Access Compliance Report

Public Rights-of-Way

(Curb Ramps)

Intersection ID: 26999	Main Street: SETON_HOUSE_LN	Cross Street: SHEPHERDLEAS_LN	Location: NW
ADA ID: A771DB1D9DE9	Ramp Type: Perp	Initial Pass/Fail: Fail	Overall Compliance: No
Severity Score: 12.5			
Codes/Mitigation Info/Possible Solution		Field Measurements/Component Compliance

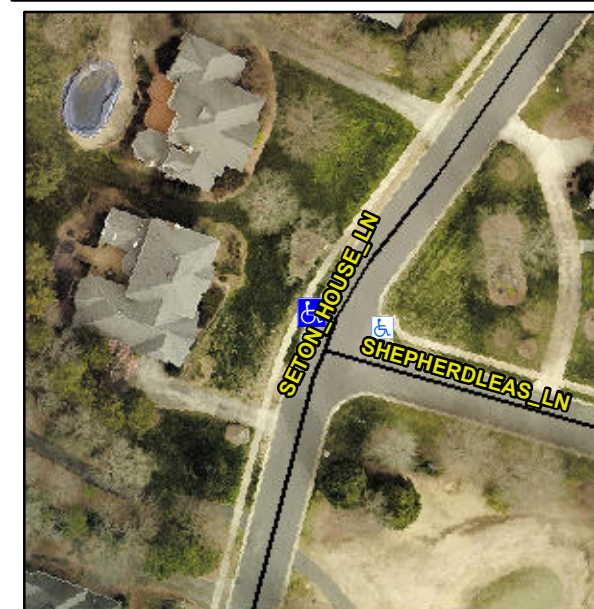
Compliance	Description	Data	Compliance	Description	Data
N/A	Ramp Length (in)	93.0	No	Ramp Slope (%)	10.5
Yes	Ramp Width (in)	50.5	Yes	Ramp XSlope (%)	0.7
N/A	Flare Type LT	N/A	N/A	Flare Type RT	N/A
N/A	Flare Slope LT (%)	N/A	N/A	Flare Slope RT (%)	N/A
N/A	Flare Traversable LT?	N/A	N/A	Flare Traversable RT?	N/A
N/A	Landing Length (in)	N/A	N/A	DWS Provided?	N/A
N/A	Landing Width (in)	N/A	N/A	DWS Contrast?	N/A
N/A	Landing Slope (%)	N/A	N/A	DWS Length (in)	N/A
N/A	Landing X Slope (%)	N/A	N/A	DWS Full Width?	N/A
N/A	Landing Curb? (Y/N)	N/A	N/A	DWS Offset (in)	N/A
N/A	Shared Landing?	N/A			
N/A	Gutter Ponding?	N/A	N/A	Gutter Slope (%)	N/A
N/A	Gutter Lip Ht (in)	N/A	N/A	Gutter X Slope (%)	N/A
N/A	Painted X Walk1?	No	N/A	Painted X Walk2?	N/A
	X Walk 1 Direction	To E		X Walk 2 Direction	N/A
N/A	X Walk 1 Width (in)	N/A	N/A	X Walk 2 Width (in)	N/A
	X Walk 1 Slope (%)	3.4		X Walk 2 Slope (%)	N/A
	X Walk 1 X Slope (%)	2.8		X Walk 2 X Slope (%)	N/A

Remove & Replace Entire Ramp.

R304.2.2
